UNITED STATES OF AMERICA
NUCLEAR REGULATORY COMMISSION

Title: **MEETING WITH ADVISORY COMMITTEE ON**
 REACTOR SAFEGUARDS (ACRS)
 PUBLIC MEETING

Date: **Thursday, April 2, 1998**

Figure 3 - Acceptance Guidelines* for Core Damage Frequency (CDF)

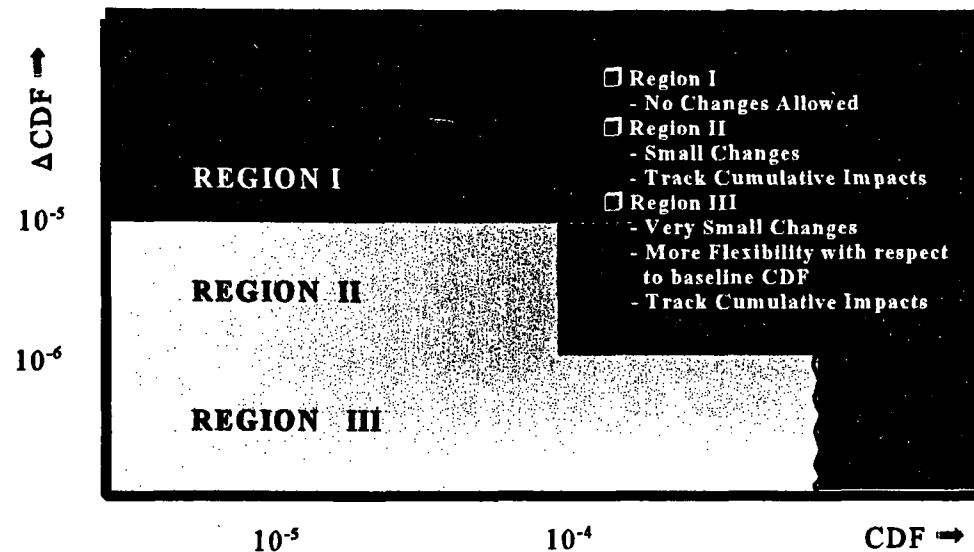
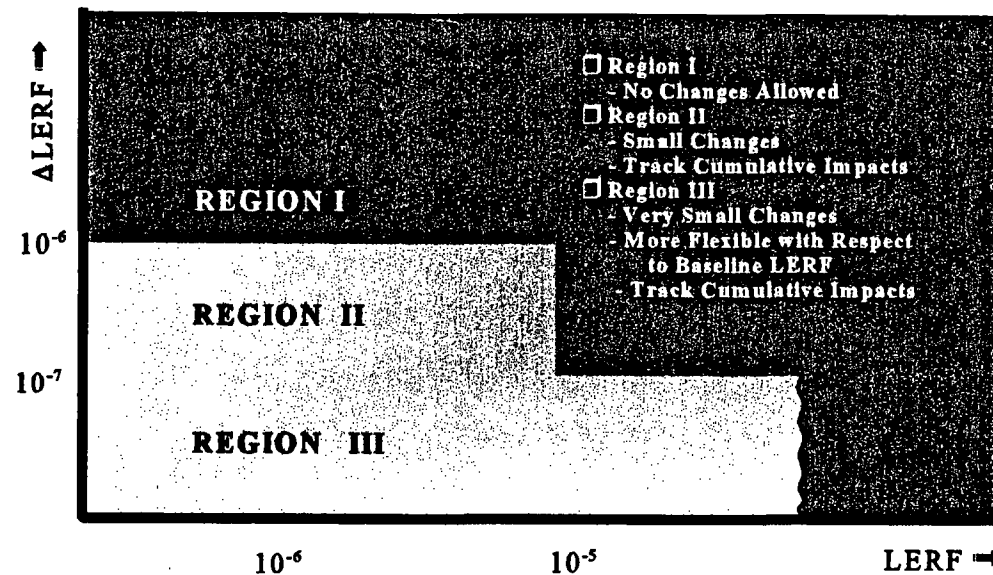
12 Second, the issue of -- well, it doesn't show very
13 well there, but as you see in the actual figures in the
14 guide, we have this shade of gray that becomes darker and
15 darker as we approach areas that we don't like, and it's
16 explained in the footnote that this means we'll pay more
17 attention, we'll scrutinize what you're doing more, and I
18 think that's very important because recognizing explicitly
19 again that there are some issues with PRA, but we are aware
20 of them, we're willing to spend the appropriate time to
21 understand what you're proposing if you are in that region.
